City of
Richmond

Report to Development Permit Panel

Re: **Application by Enrich Cambie No 5 Development Corp. for a General Compliance Ruling at 11671 Cambie Road**

That the attached plans involving changes to on-site trees, building cladding, privacy fencing and other minor site features, be considered to be in General Compliance with the approved Development Permit (DP 17-772227).

DP 17-772227
 MAY 08 2018 PROPOSED SITE PLAN SCALE: 1"=20'-0"
 PLAN #1

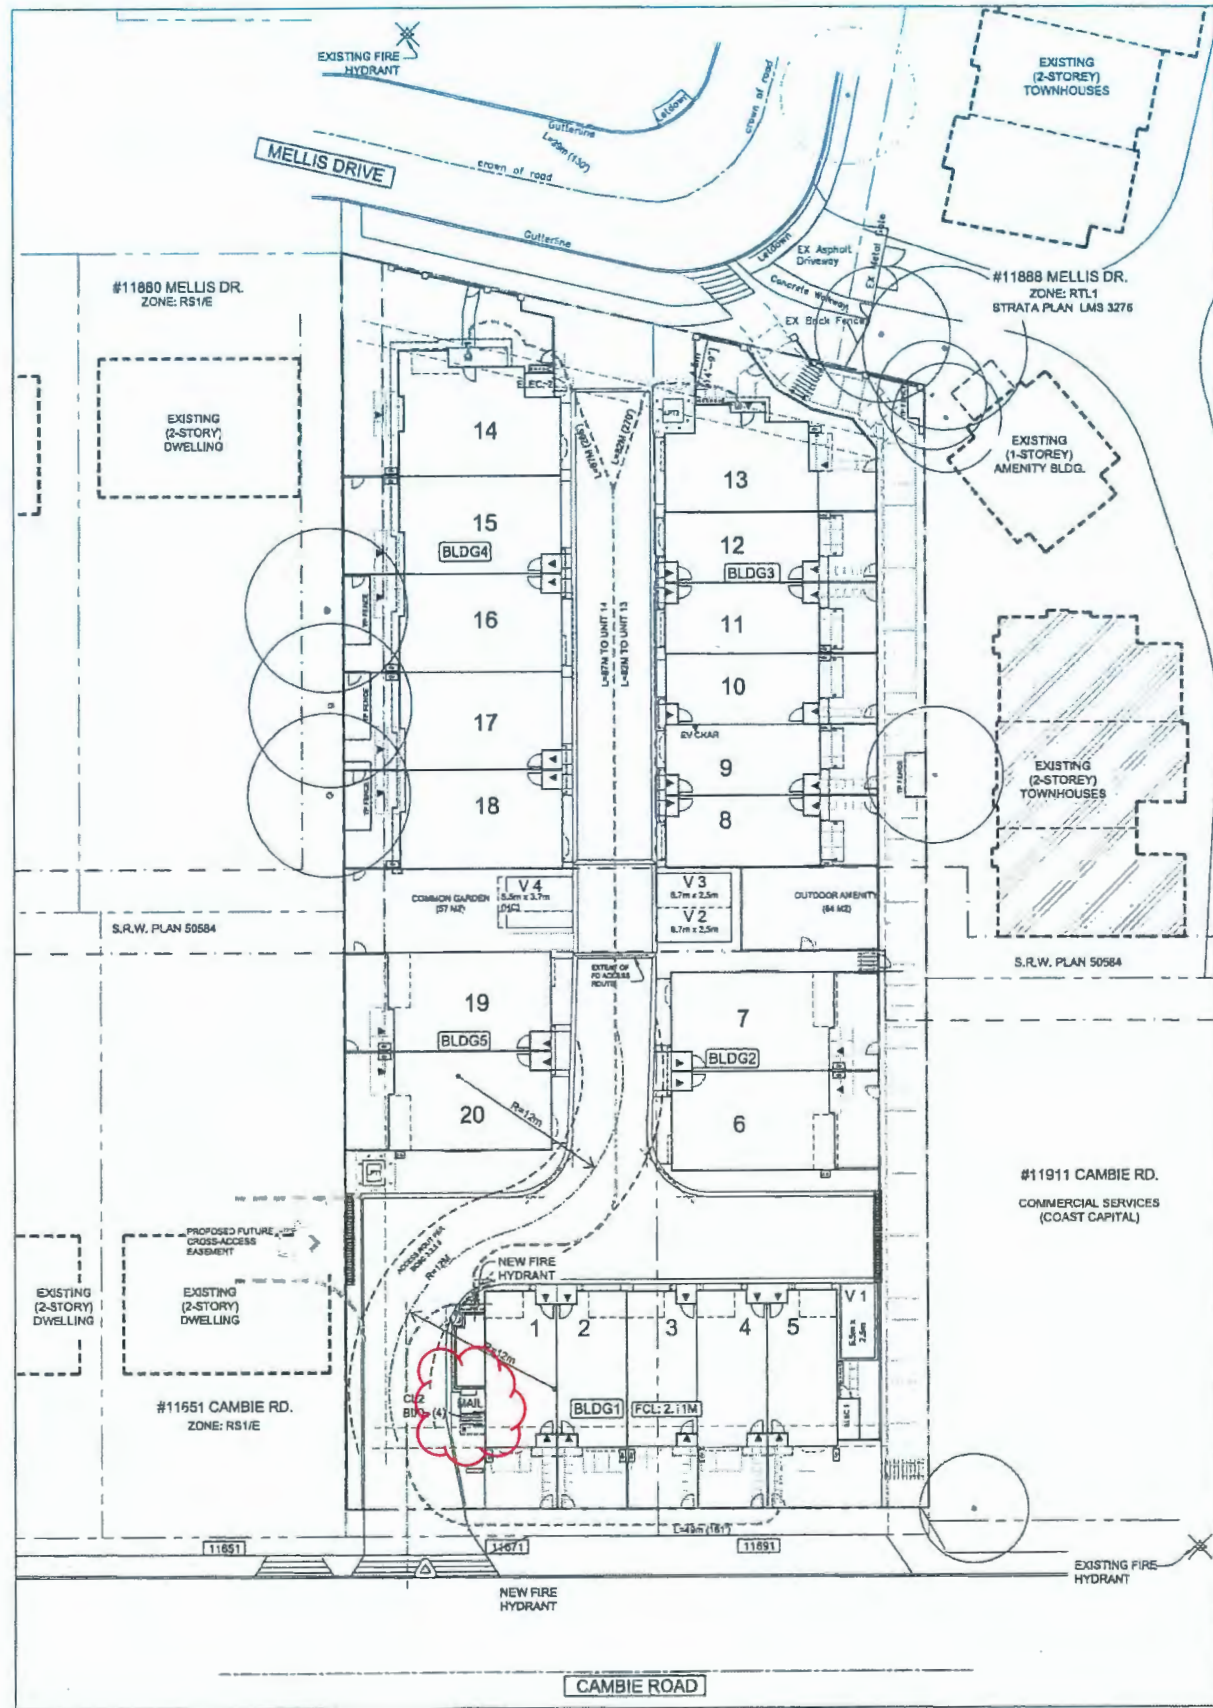
C. Drive Aisle Crossing (See Plan #1)

- The approved design incorporated a slightly raised area on the internal drive aisle in front of the visitor parking spaces and the outdoor amenity areas at the center of the site for traffic calming purposes.
- Through site construction it was determined that this feature was not possible to include due to site drainage concerns as the surface rainwater is designed to flow continuously from the T-intersection to the north and the raised surface would disrupt this flow.
- The developer has installed 4-inch visibility speed bumps as an alternative measure to achieve the traffic calming effect without disrupting site drainage.
- The proposed alteration has been reviewed and accepted by City Transportation staff.

D. Privacy Fencing (See Plan #1)***Privacy Fencing on Cambie Road***

- The approved DP noted that the six-foot-high privacy fencing dividing unit patios along Cambie Road was not permitted to project into the open yard past the covered entry porch.
- Through a construction oversight the privacy fencing installed extended past the overhanging entry canopies.
- To reduce the impact the lattice dividers have been reduced to 4 ft. in height.

Privacy Fencing adjacent to the Pedestrian Walkway)

- The approved DP noted that the six-foot-high wooden dividers for units of Building 3, along the public walkway, were not permitted to project into the open yard past the covered entry porch.
- Through a construction oversight the solid wooden privacy fencing was installed and extended past the overhanging entry canopies.
- Staff are supportive of these dividers remaining at 6 ft. in height as they provide a visual screen between patios as well as a solid noise barrier for the condenser units located in each yard.

E. Canada Post Mailbox Kiosk (See Plan #1)

- Through further consultation during the construction phase of the project, it was determined by Canada Post that the mailbox kiosk on-site should be relocated from the west side of Building 5 to the south side of Building 1.
- The relocation was required by Canada Post due to the presence of a manhole cover which was deemed a potential tripping hazard and not acceptable for postal worker safety.
- The new location of the kiosk continues to be visible and is located opposite the main drive entry into the complex from Cambie Road. This area was previously occupied by small grasses and shrubs.

PLAN #4F

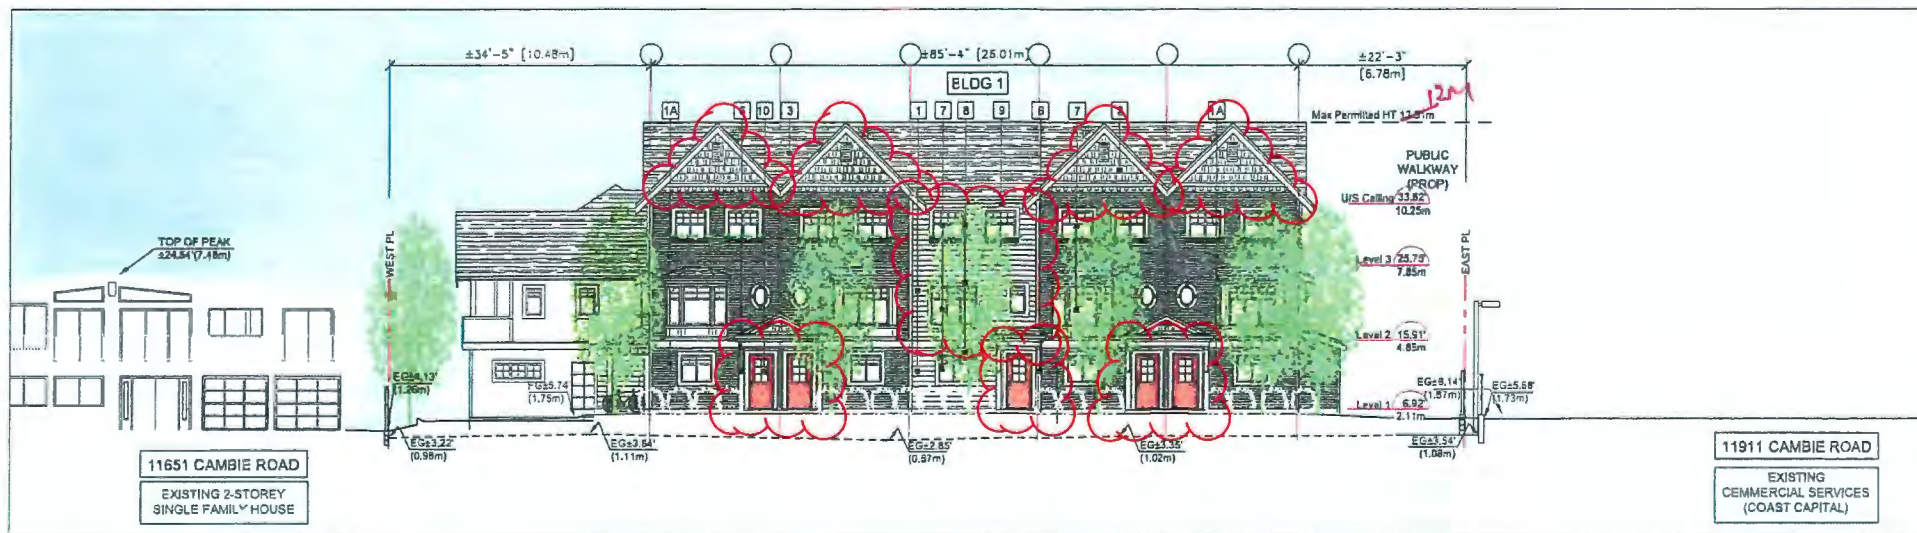
B. Cladding Material (See Plan #4F)

- The applicant has incorporated subtle cladding changes on all townhouse buildings throughout the site.
- Portions of the Hardie plank siding have been changed from gray mist to an off-white tan colour.
- Dark brown unit entry doors have been installed in place of red entry doors.
- Board and batten gable shingles have been incorporated in the building's roofline in place of fibre-cement shingles.
- Staff support these changes to the cladding as they are subtle changes with lighter tones and contrasting materials, offering an overall cohesive look to the development.

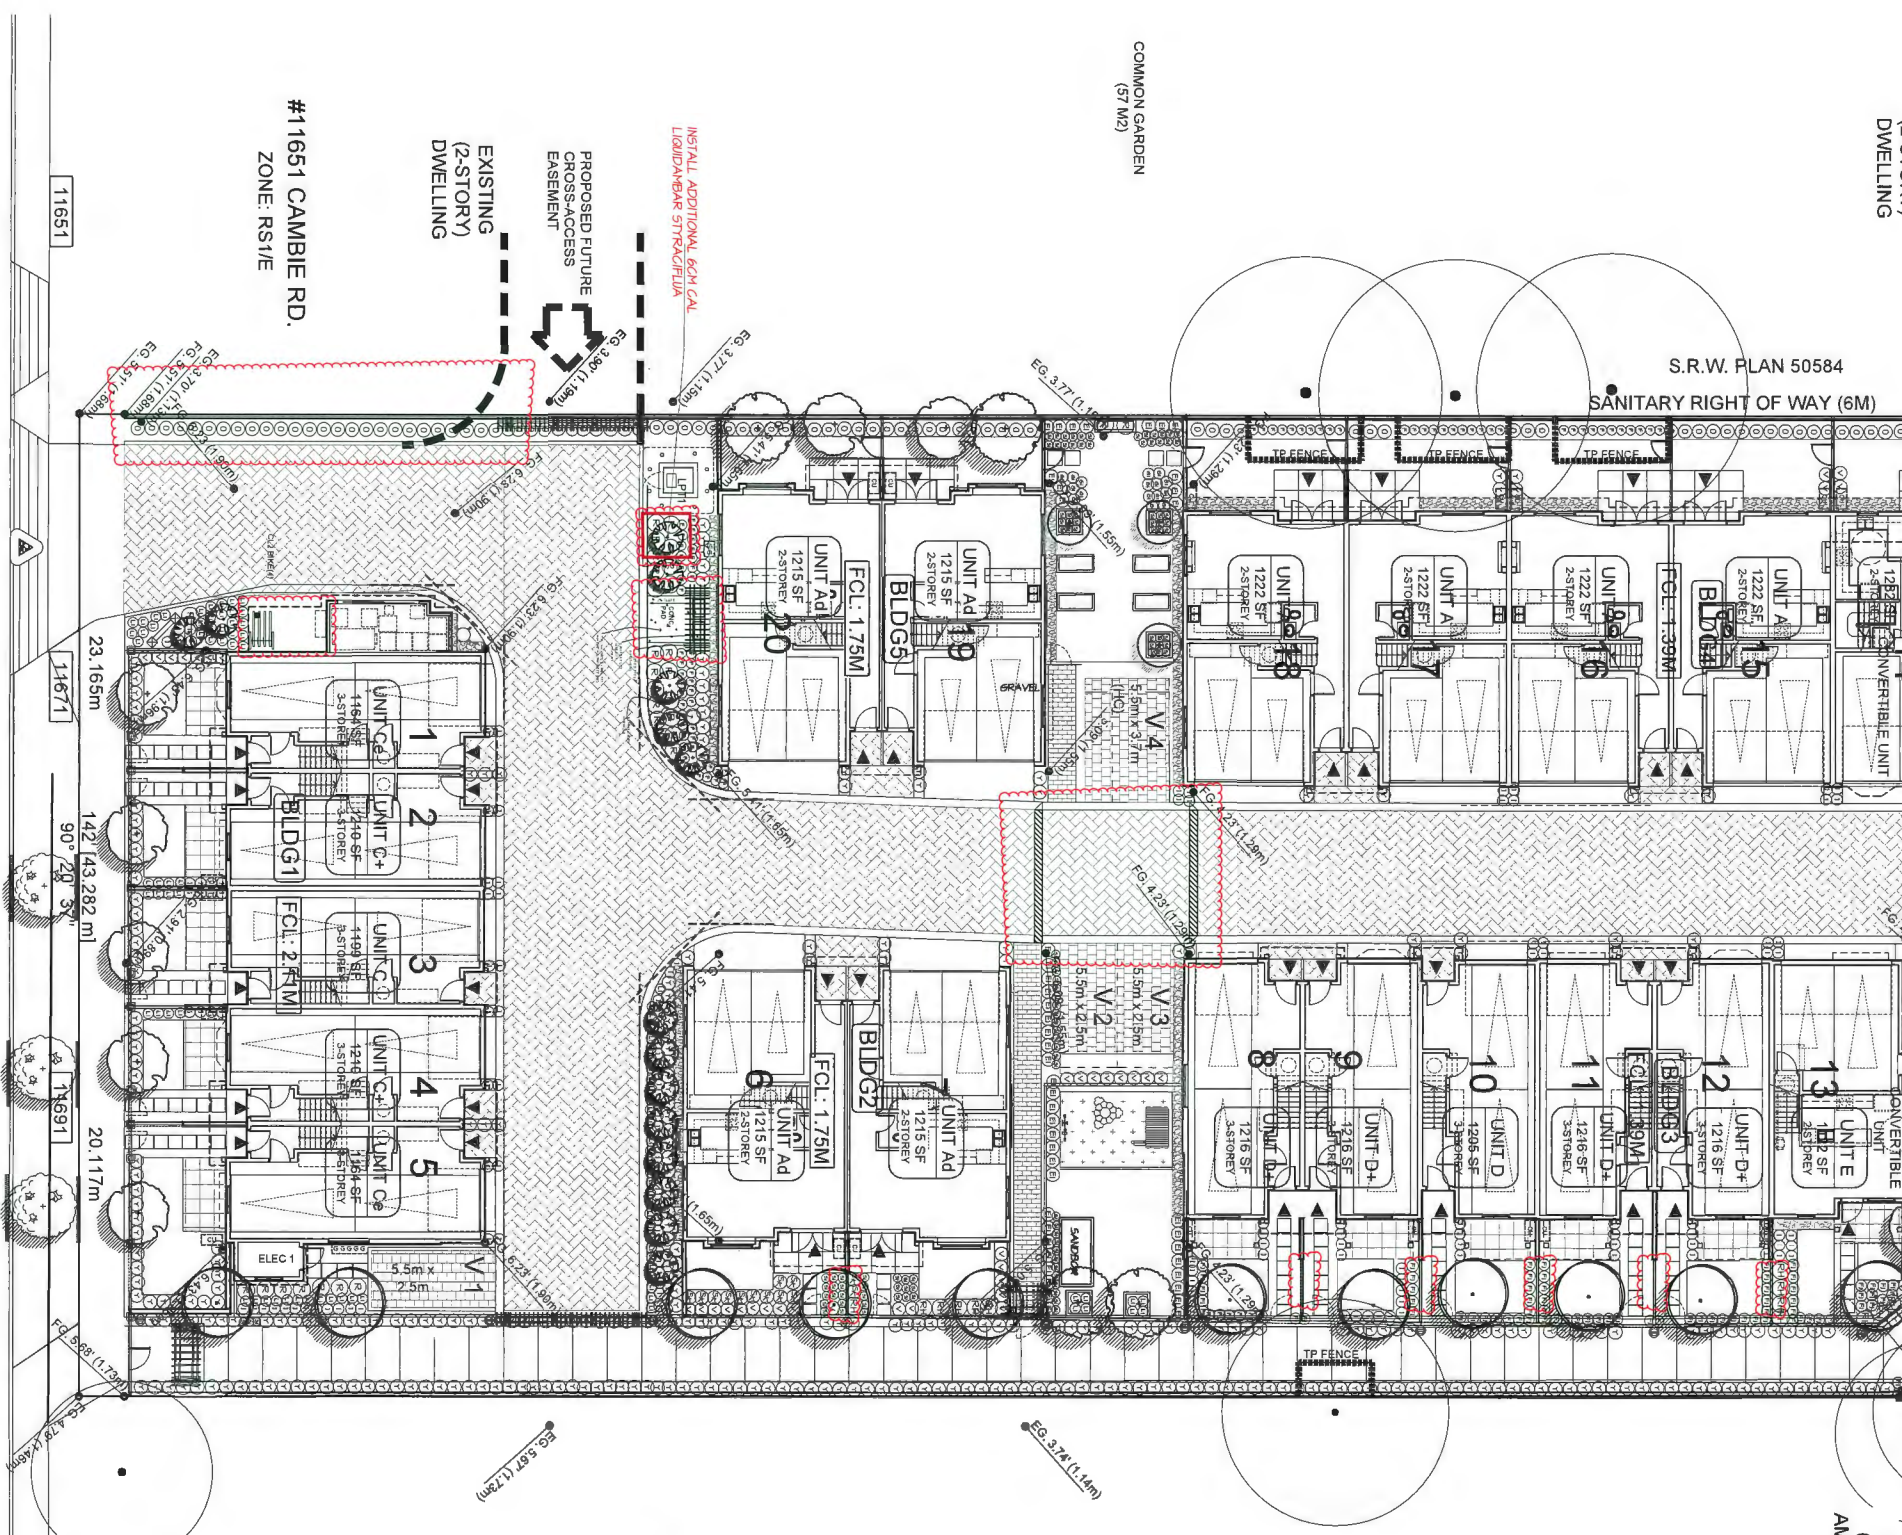
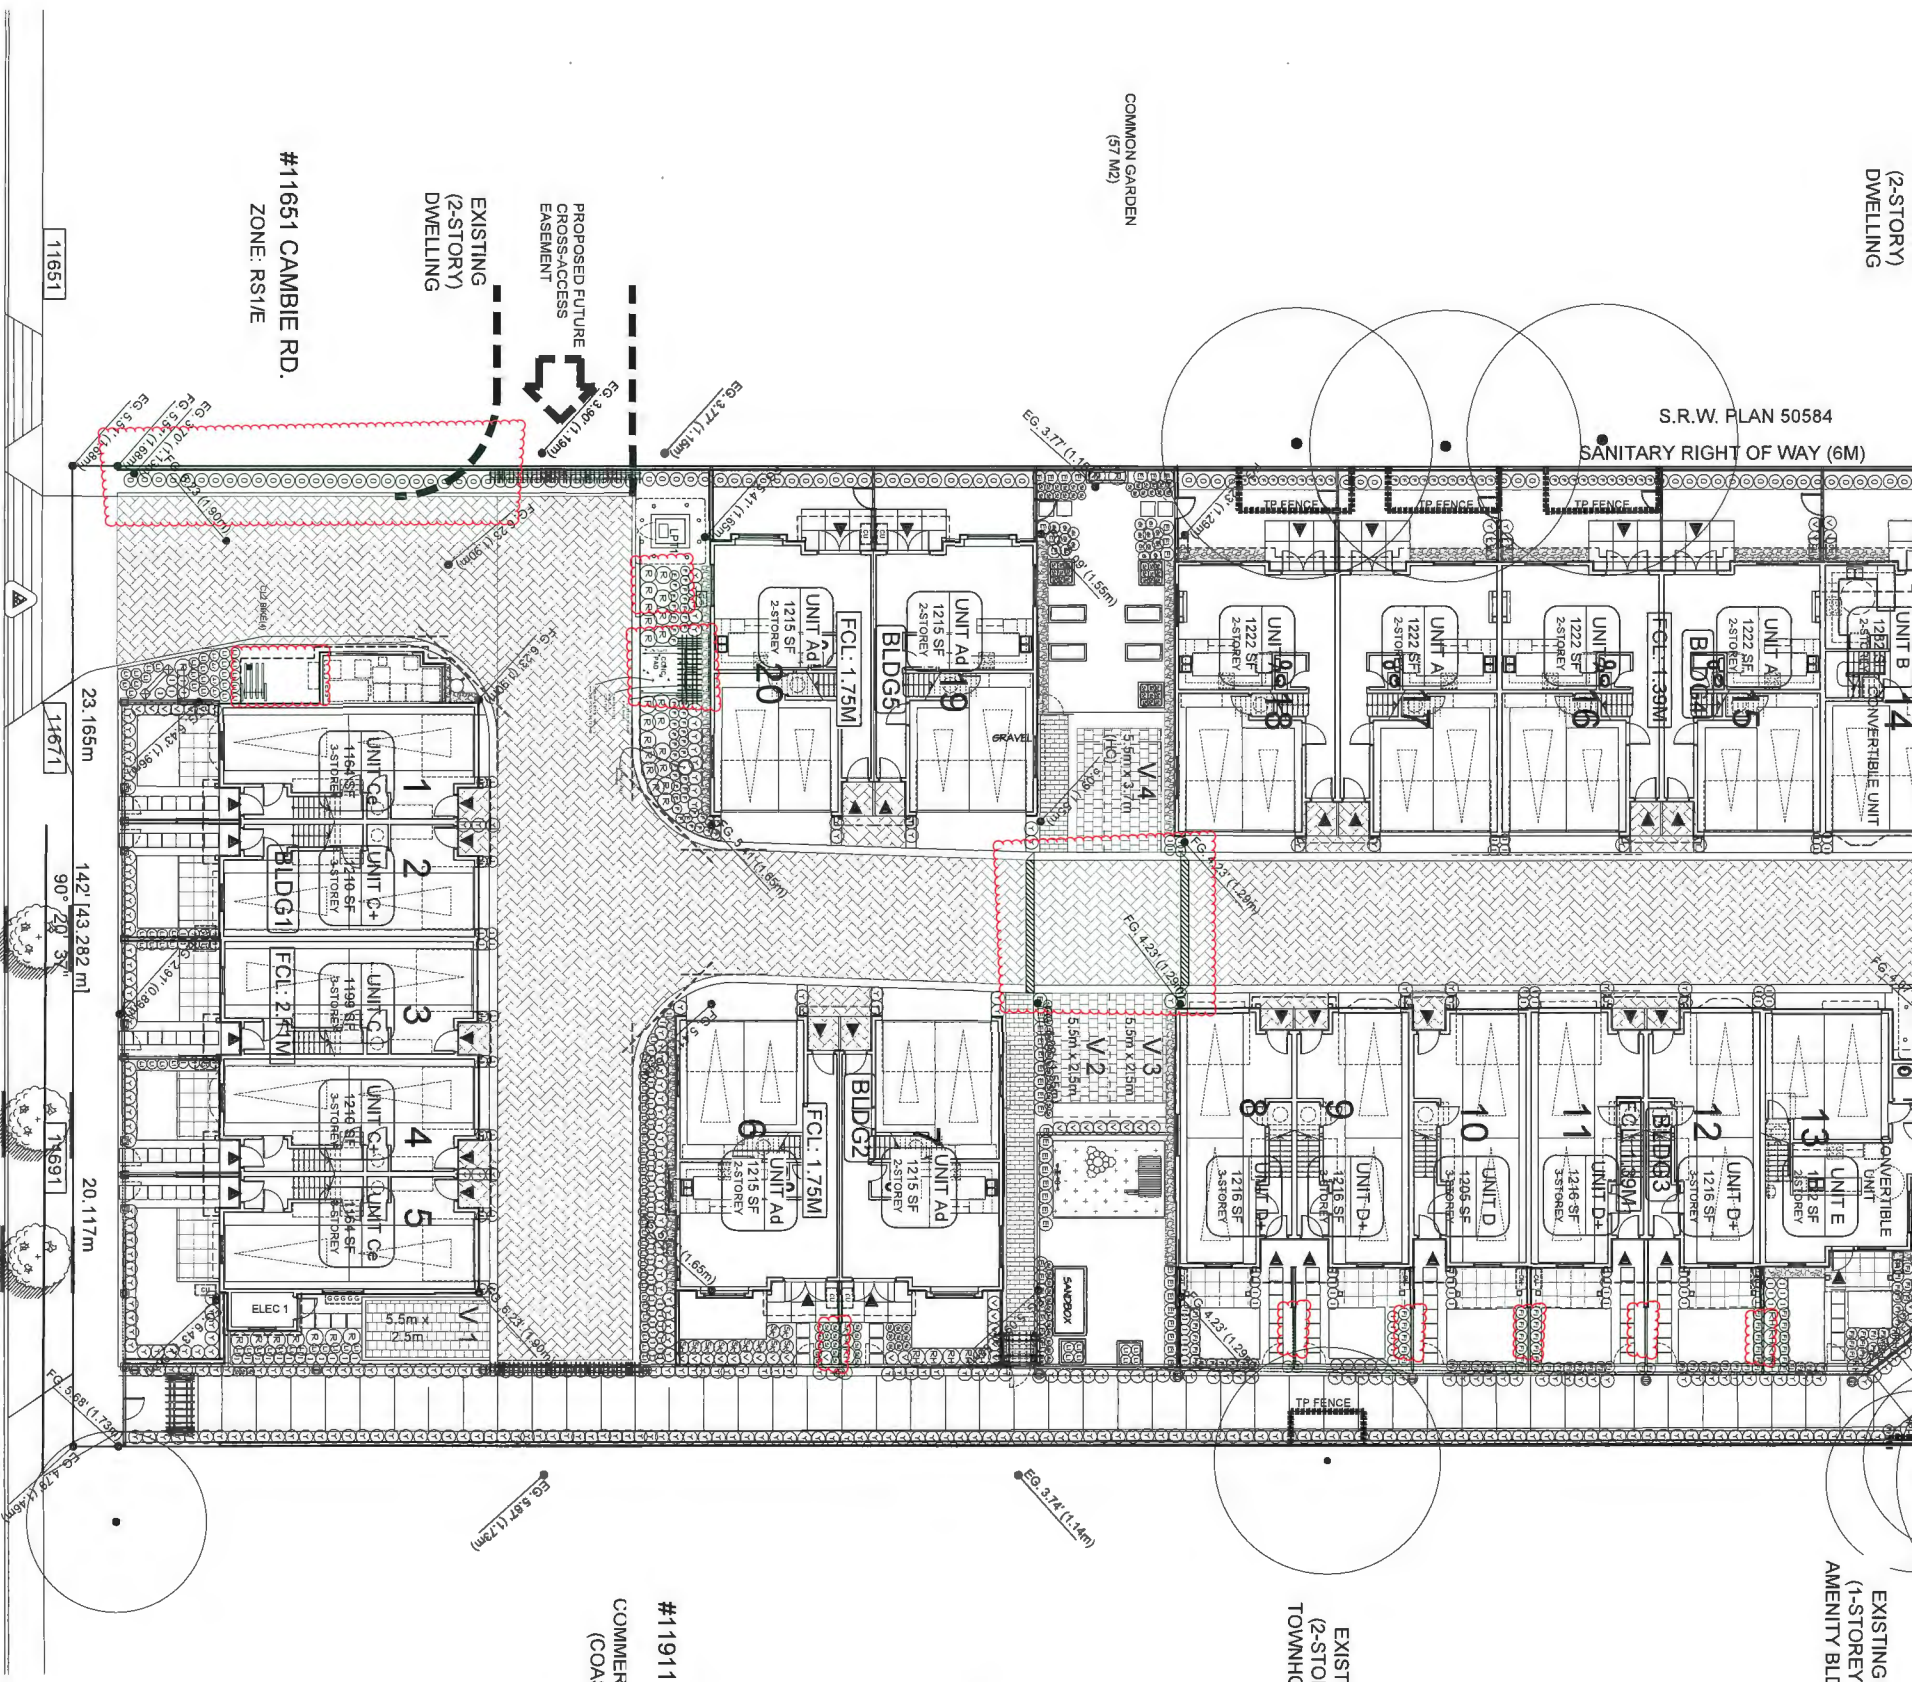
A. On-Site Trees (See Plan #3A)

- Through the prior rezoning and DP application the applicant was required to plant 14 replacement trees and had proposed to plant 61.
- Out of the total of 61 trees, only 56 trees were planted due to spatial constraints and unforeseen underground on-site servicing requirements that were not confirmed at the DP stage. A letter was received from the applicant's landscape architect expressing concerns about site overcrowding and potential impact to tree health and longevity

- The applicant has since installed two new trees on-site including a 4 m White pine tree at the bermed planting area and an 8 cm cal. Sweet gum adjacent to the mailboxes. This brings the total number of trees planted on-site to 58.

- In lieu of the three trees that could not be accommodated on-site, the applicant has agreed to voluntarily contribute \$2,304.00 to the City's Tree Compensation Fund prior to Council's consideration of the general compliance ruling.
